**SPS**EDMS NO.
1377890REV.
0.1VALIDITY
DRAFTREFERENCE
SPS-MD-EC-0001

ENGINEERING CHANGE REQUEST

Modification of the magnetic bumps for safe operation of the BIPM in SPS LSS5

Figure 4. Modified bump compensation in half-cell 516

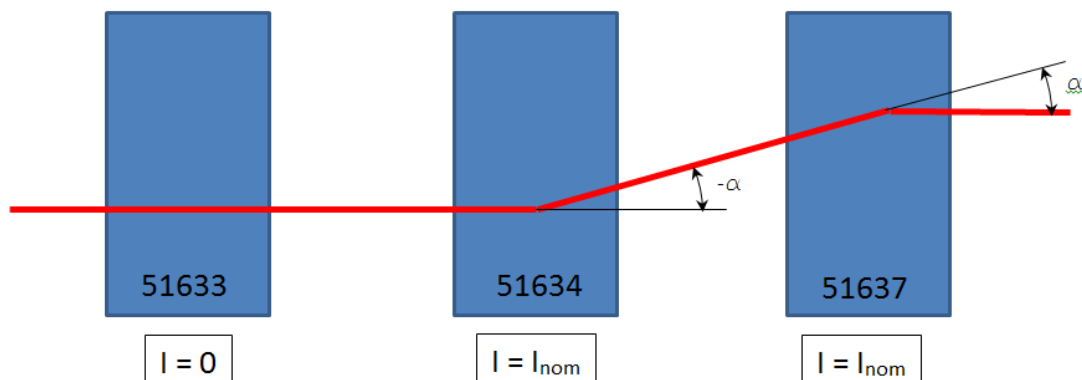
During the winter TS 2012/2013 the electrical circuit of the vertical BIPM set-up magnets in 516 were reconfigured in order to test a single-compensator scheme. The magnets MDHW 51634 and MDHW 51637 were connected in series (with opposite polarities) to power converter MDHW51633M and the magnet MDHW 51633 was disconnected and power converter MDHW51634 consigned. The magnetic bump principle is illustrated in Figure 4.

Figure 5. Modified bump compensation of both circuits

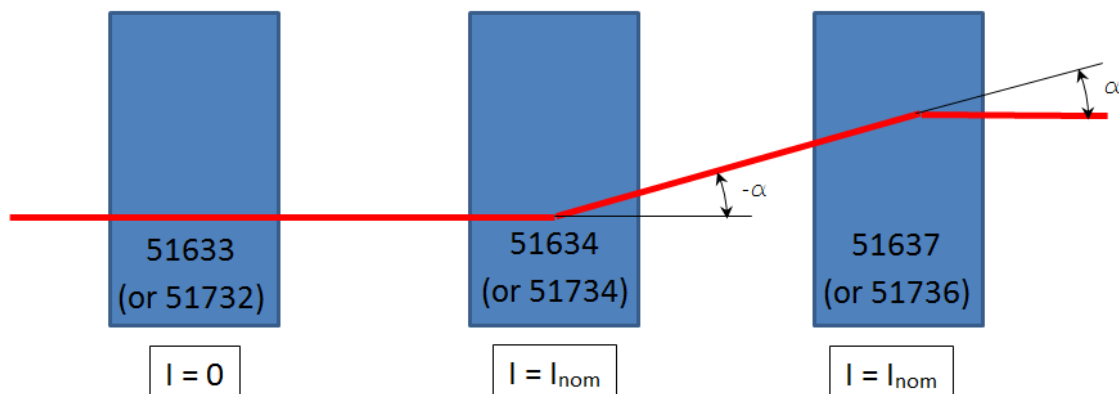
It is proposed to permanently modify the magnetic bump layouts both in half-cells 516 and 517 by using only two magnets powered in series with opposite polarity in a single circuit, instead of 3 powered with two independent circuits, as shown in Figure 5. This would provide a passive safety against any converter failure.

The new layout will not allow by itself to fully close the bump, but the offset generated is low due to the closeness of the two magnets (1.47 m between the magnetic centres), and can be recuperated by the adjacent orbit correctors, as could be verified during the test on January 21st, 2013. The resulting orbit distortion in case of failure is around 0.2mm. This is acceptable for extraction but the transfer lines will have to be re-steered. However the situation is much better than with 2 converters where a failure would result in a destructive total beam loss.

Figure 6. Modified MDVW517 electrical diagram. Modification of the MDHW516 circuit follows the same principle.

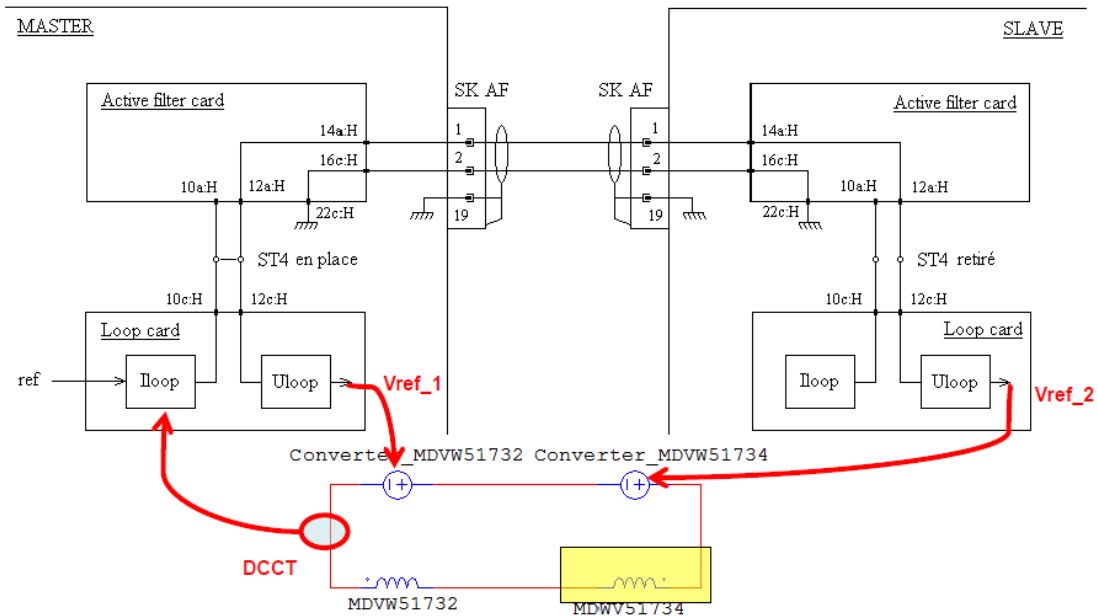
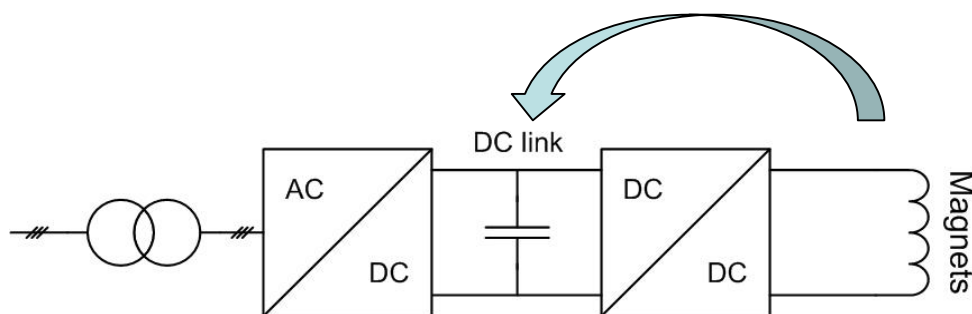
To achieve the requested ramp time to nominal current, the voltage rating of one single power converter type NO7 is not sufficient as could be observed during the tests in January 2013. To avoid the replacement of the converter, it is proposed to assemble the two NO7 converters in series in each circuit in master/slave mode. The control electronics for this mode has already been developed and is available in TE/EPC. The DC cable links for the series connection of the converters - typically two 3 m long pieces of UCH1S (or equivalent) cable - between the adjacent master and slave converters for each set-up are needed, as well as a modification of the

cabling connections on the magnet (TE/MSC). The modification has to be implemented in both the horizontal (half-cell 516) and the vertical (half-cell 517) monitors. The principle is illustrated in Figure 6.
